HISTORIC LANDMARK COMMISSION
APPLICATION FOR A CERTIFICATE OF APPROPRIATENESS
JULY 5, 2023
HR-2023-059459
ROGERS-WASHINGTON-HOLY CROSS
2000 MAPLE AVENUE

PROPOSAL

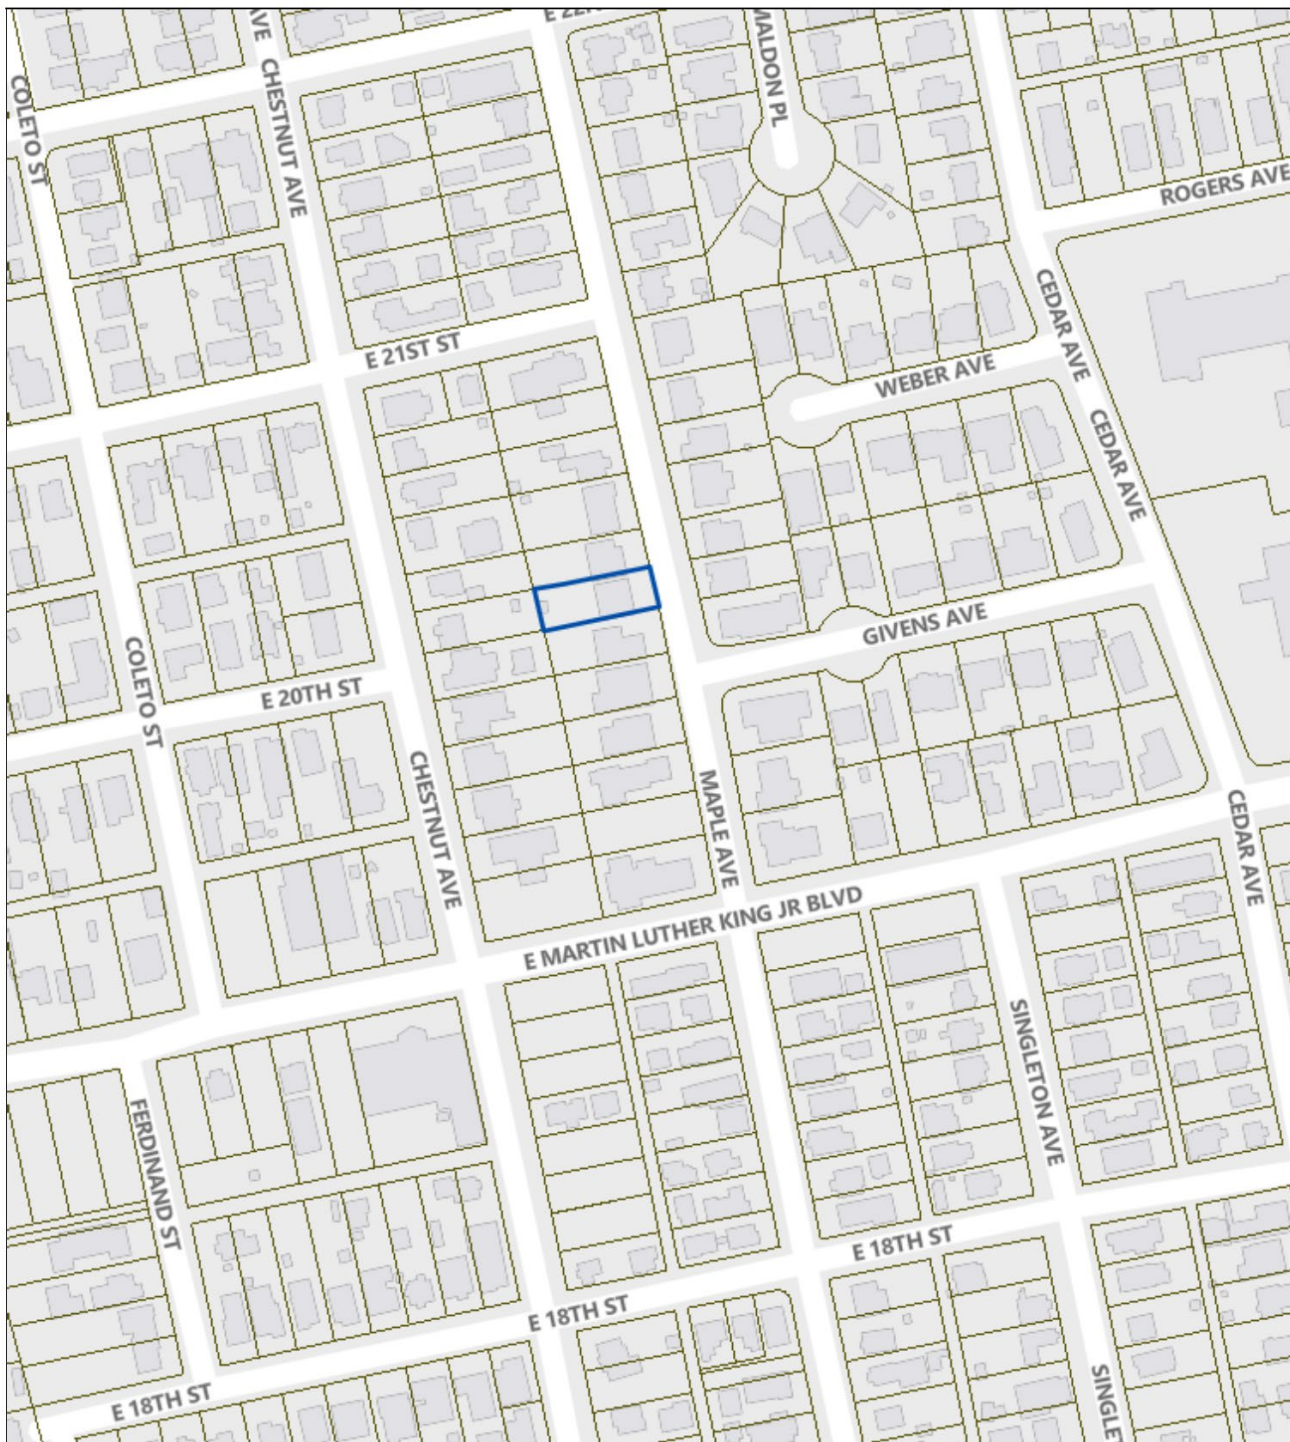
The work has altered windows and cladding at protected façades.

Original exterior masonry has been replaced with non-matching masonry.

The new shingles are an appropriate replacement material. The roofline was not altered.

Original 2:2 aluminum windows have been replaced with 1:1 vinyl windows. Window openings have not been altered.

The project meets few of the applicable standards.

Consider whether the unauthorized alterations have rendered the house non-contributing to the district. If so, require replacement of altered windows and veneer with compatible elements meeting the district design standards.
